Submissions Report for
Concept Plan Approval
(Residential, Commercial / Tourist Development and
Environmental Works); and

Project Application Approval
(Stage 1 'Environmental Works')

Lot 1 DP 374315, Lot 4 DP 615261 and
Part Crown Reserves (R82555 and R754444),
Ocean Drive, Lake Cathie

Application No. MP07_0010

Extract from GLCBH UDMP (p.29)

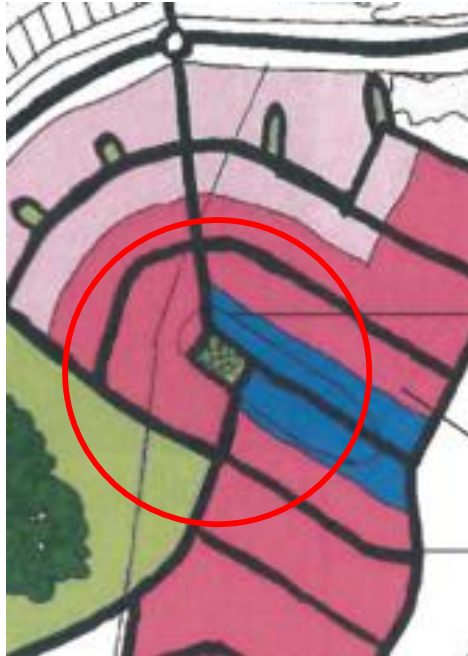
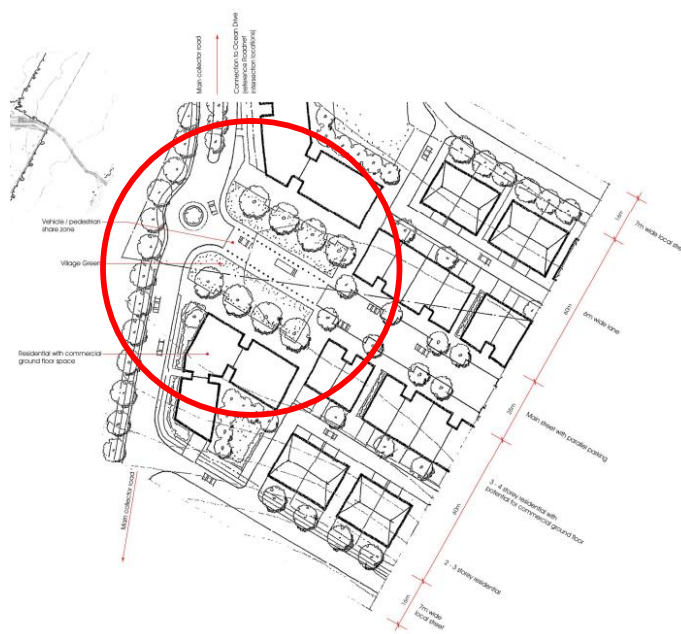
Response to Issue:

The schematic drawings on page 29 of the UDMP illustrated, by example, a village green connected to open space and the beach environment by a main street.

The Concept Plan (CP) is consistent with and has expanded upon the open space recommendations of the UDMP, as follows:

- The CP provides for a significant urban square ('Village Green') of approximately 50 x 55 metres dimension on the hill top. The urban square comprises in small part a shared vehicle / pedestrian space and in large part pedestrian and park function. The urban square has an active urban edge of commercial ground floor space and will provide opportunities for outdoor dining, passive seating, meeting and children's play.

significant opportunity for casual recreation and that the proposed Village Square, as illustrated below, is consistent with the design criteria set out by the UDMP. While the pocket park at the eastern end of the mainstreet is additional to that envisaged in the UDMP it serves the purpose of providing a public pedestrian link between the Hilltop Village and the access to Rainbow Beach.
